Item Name: Crosstube Turning Detail

DART AEROSPACE LTD	Work Order:	97426
Description: Crosstube Assembly (412 High Aft)	Part Number:	D412-664-243
Inspection Dwg: D412-664-243 Rev: E		Page 1 of 2

DRAWING NO. D412-664-243	TITLE CROSSTUBE ASSEMBLY (412 HI AFT)	REV. E	DART AEROSPACE LTD ENGINEERING ORDER		D.E.O. NO. D412-664-243-E-1	SHEET NO. SHEET 1 OF 2	SCALE NTS
DRAWN	CHECKED	MFG. APPR.	APPROVED		DE APPR.		
DATE 11.03.31	DATE 11/03.31	DATE 11.03.31	DATE 11/03.31		DATE 11.03.31

DRAWING NO. D412-664-243	TITLE CROSSTUBE ASS'Y (412 HI AFT)	REV. E	DART AEROSPACE LTD ENGINEERING ORDER		D.E.O. NO. D412-664-243-E-2	SHEET NO. SHEET 1 OF 1	SCALE NTS
DRAWN <i>MP</i>	CHECKED <i>ASS</i>	MFG. APPR. <i>RE</i>	APPROVED <i>MP</i>		DE APPR. <i>#</i>		
DATE 11.09.07	DATE 11.09.19	DATE 11.09.19	DATE 11.09.19		DATE 11.09.19

**D412-664-243
ASSEMBLY DETAIL**

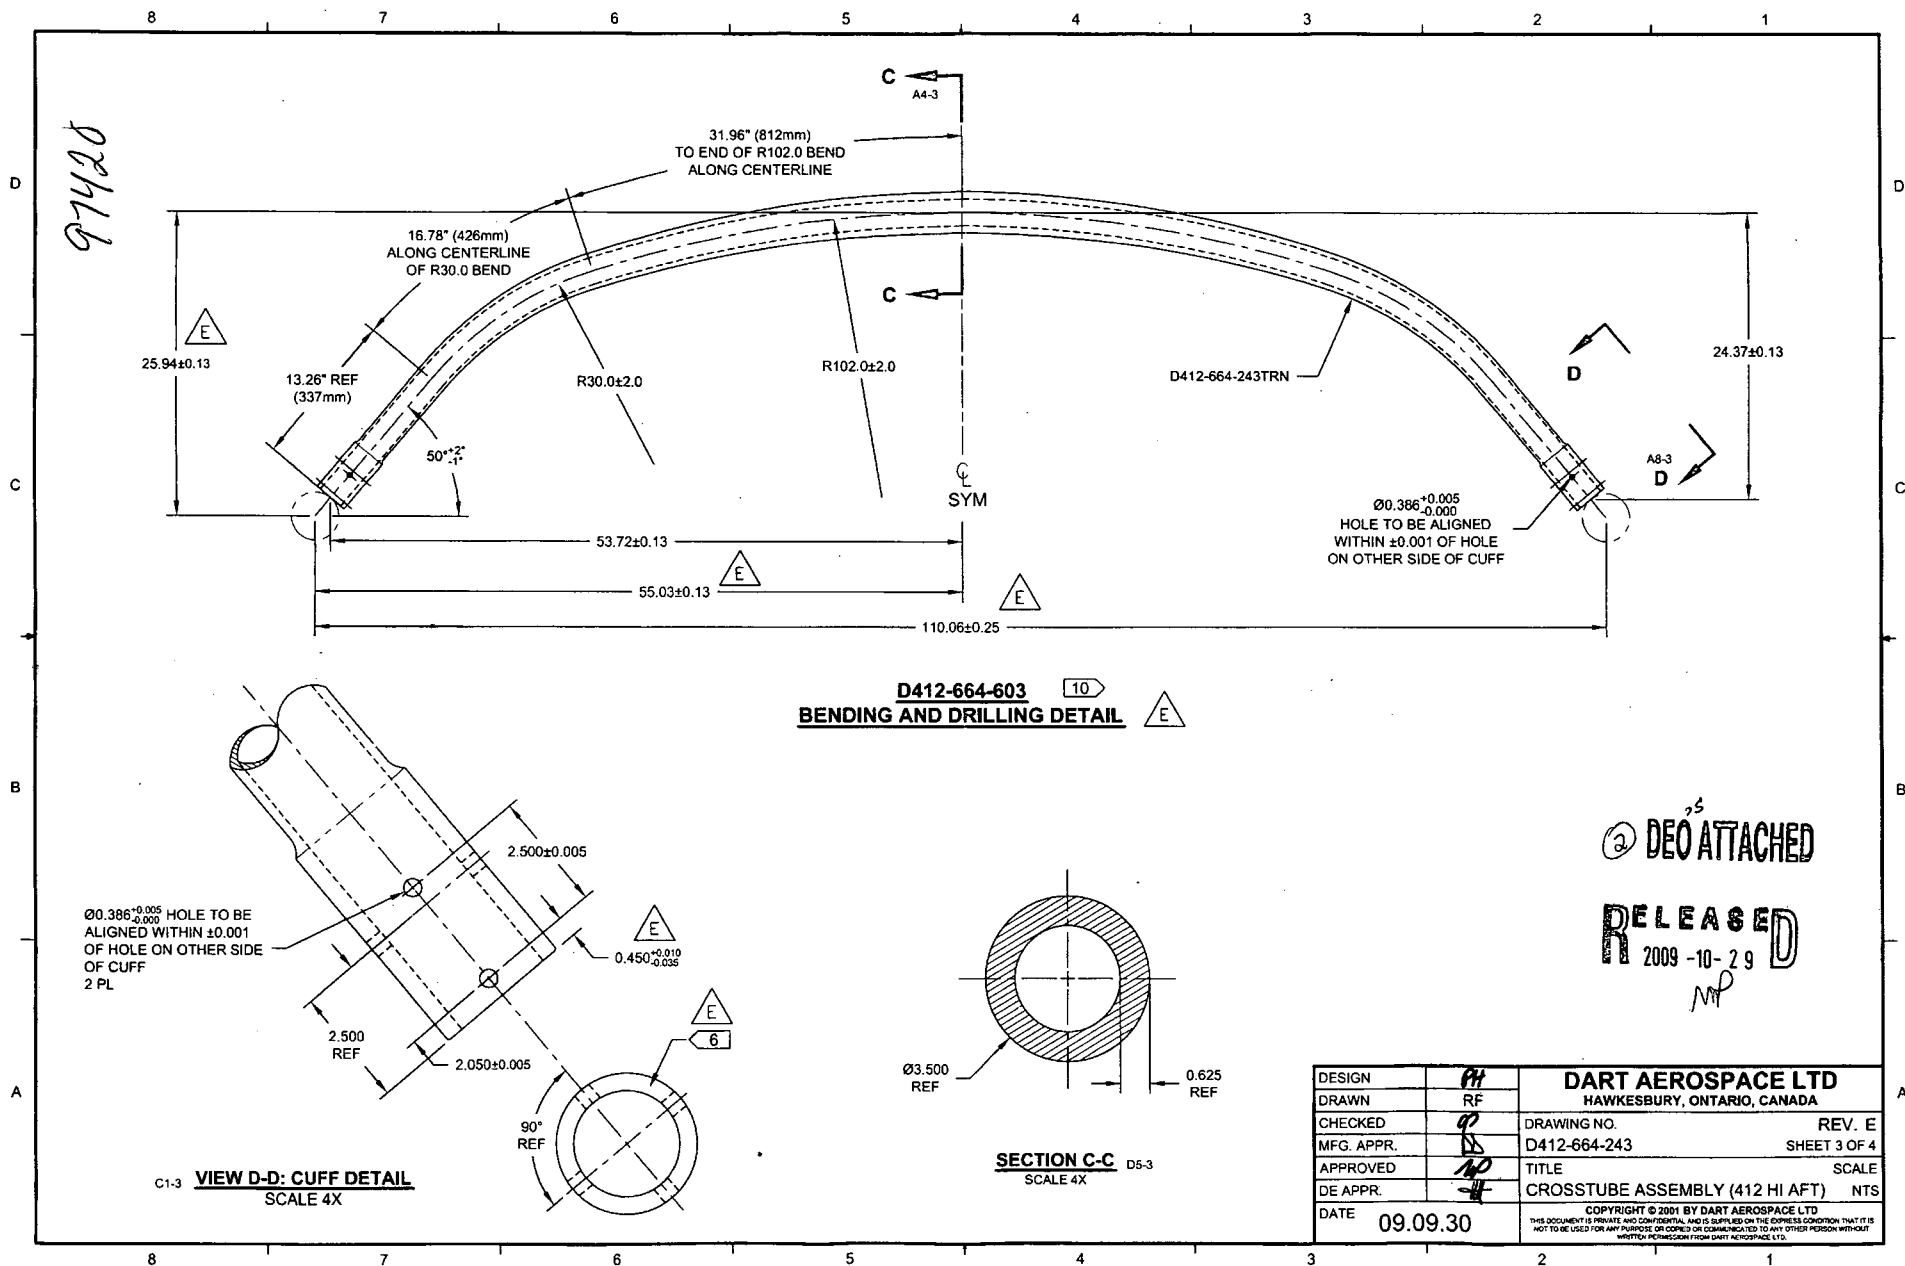
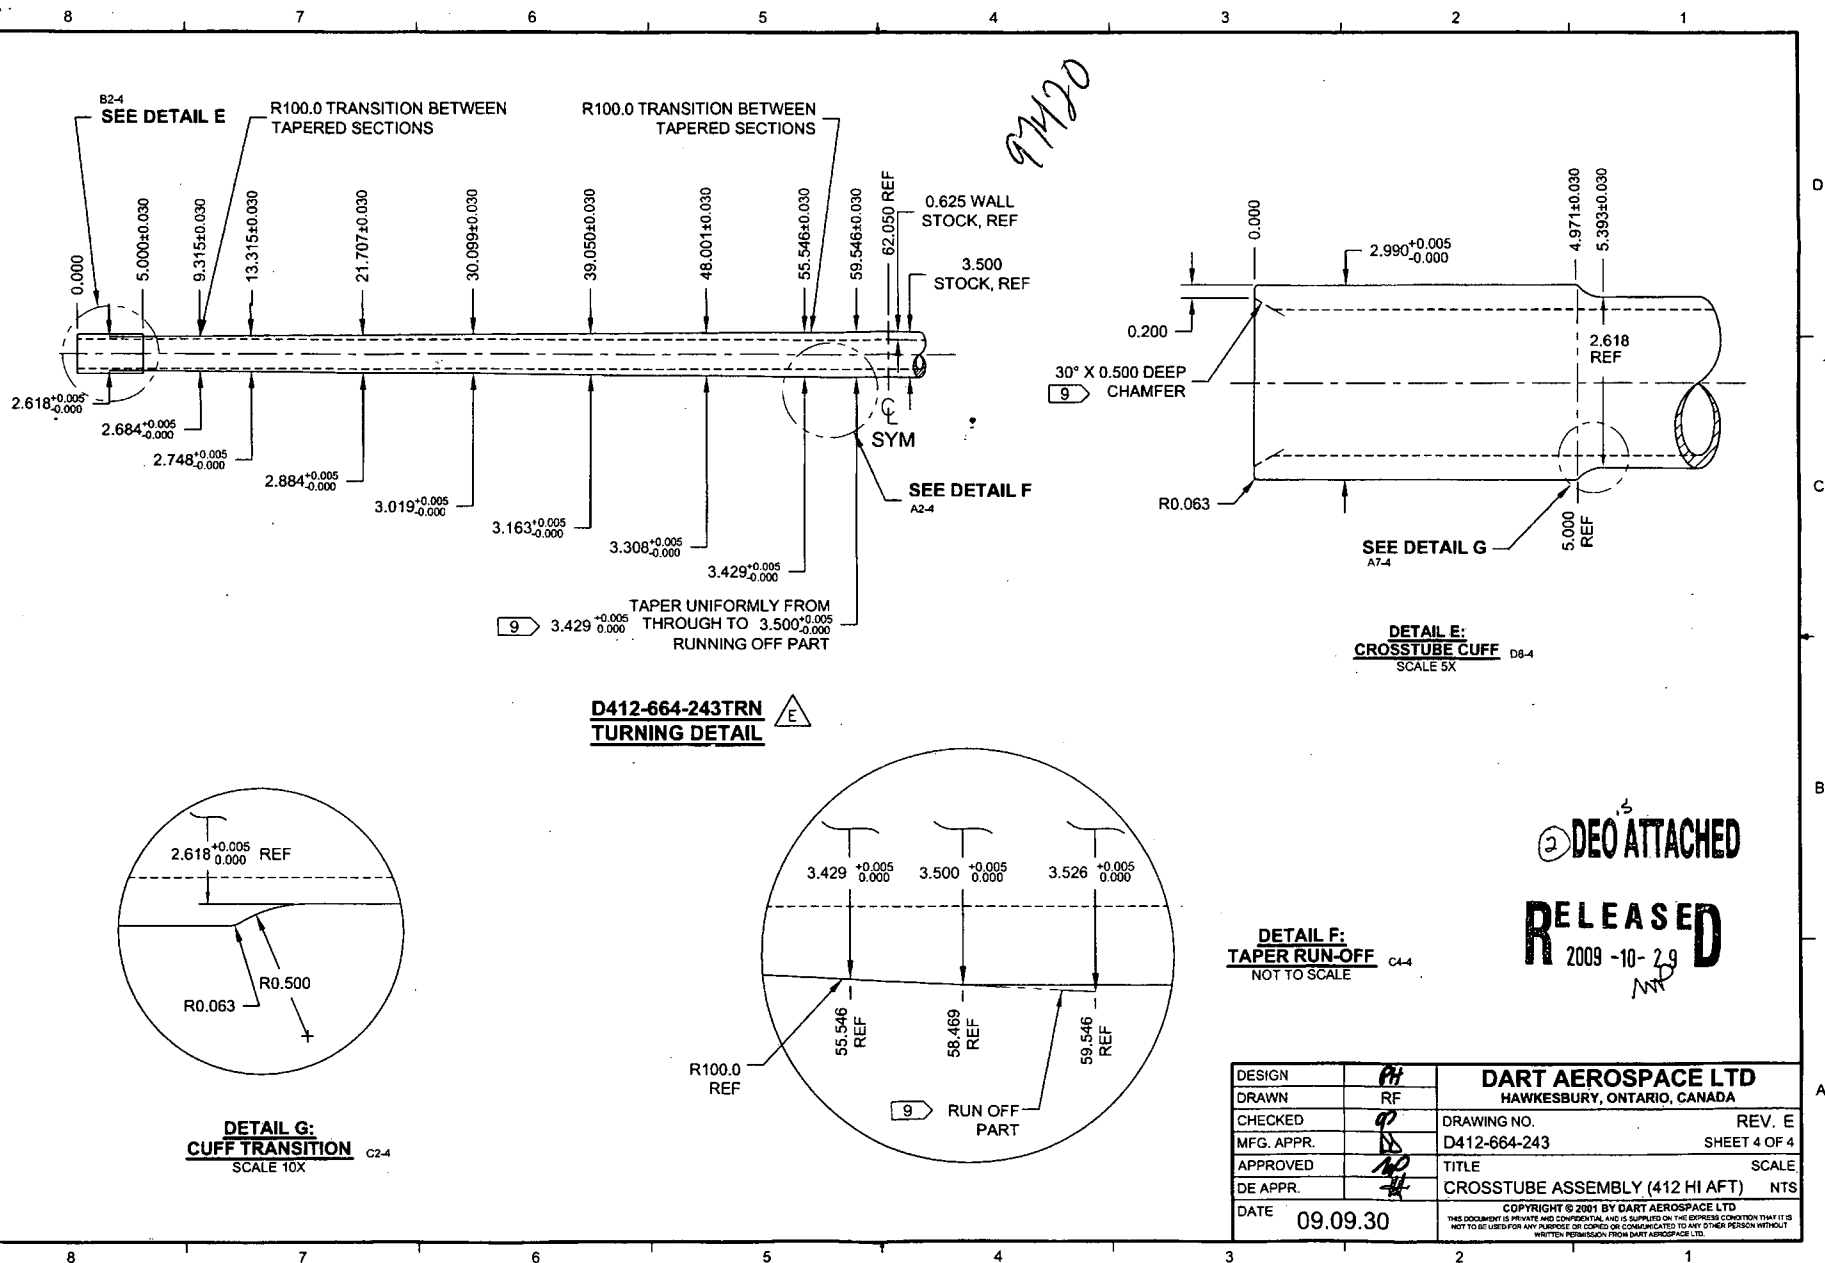
REMOVED ABRASION STRIP IN FAVOR OF A THIN LAYER OF PROSEAL 890.

D3189-1 CHAFING SHIELD (1, INSTALLED OVER PROSEAL 890)
MS21920-28 CLAMP, 2X
2 PL

D2856-600-1009 ABRASION STRIP
D3189-1 CHAFING SHIELD (1, INSTALLED OVER ABRASION STRIP)
MS21920-28 CLAMP, 2X
2 PL

MASK AREA PRIOR TO PAINTING AND
APPLY CLEAR COAT AFTER PAINTING

**D412-664-243
ASSEMBLY DETAIL**

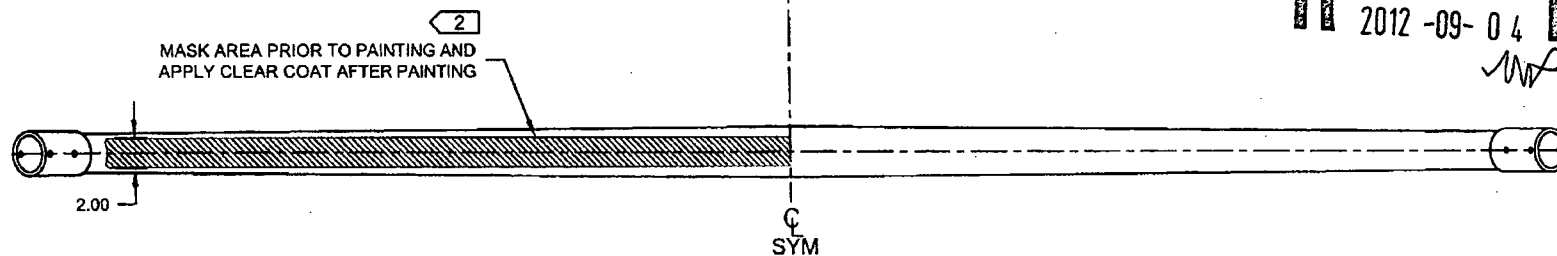
REMOVED ABRASION STRIP IN FAVOR OF A THIN LAYER OF PROSEAL 890. UPDATE INSTALLATION OF CHAFING SHIELDS AND REDUCE TORQUE TO 40-50 IN-LBS. THIS ENGINEERING ORDER SUPERCEDES DEO D412-664-243-E-1.

D3189-1 CHAFING SHIELD (1, INSTALLED OVER PROSEAL 890)
MS21920-28 CLAMP, 2X
2 PL

D2856-600-1009 ABRASION STRIP
D3189-1 CHAFING SHIELD (1, INSTALLED OVER ABRASION STRIP)
MS21920-28 CLAMP, 2X
2 PL

11.83
TO CLAMP

11.60
TO
CHAFING
SHIELD

4.00
CLAMP SPACING
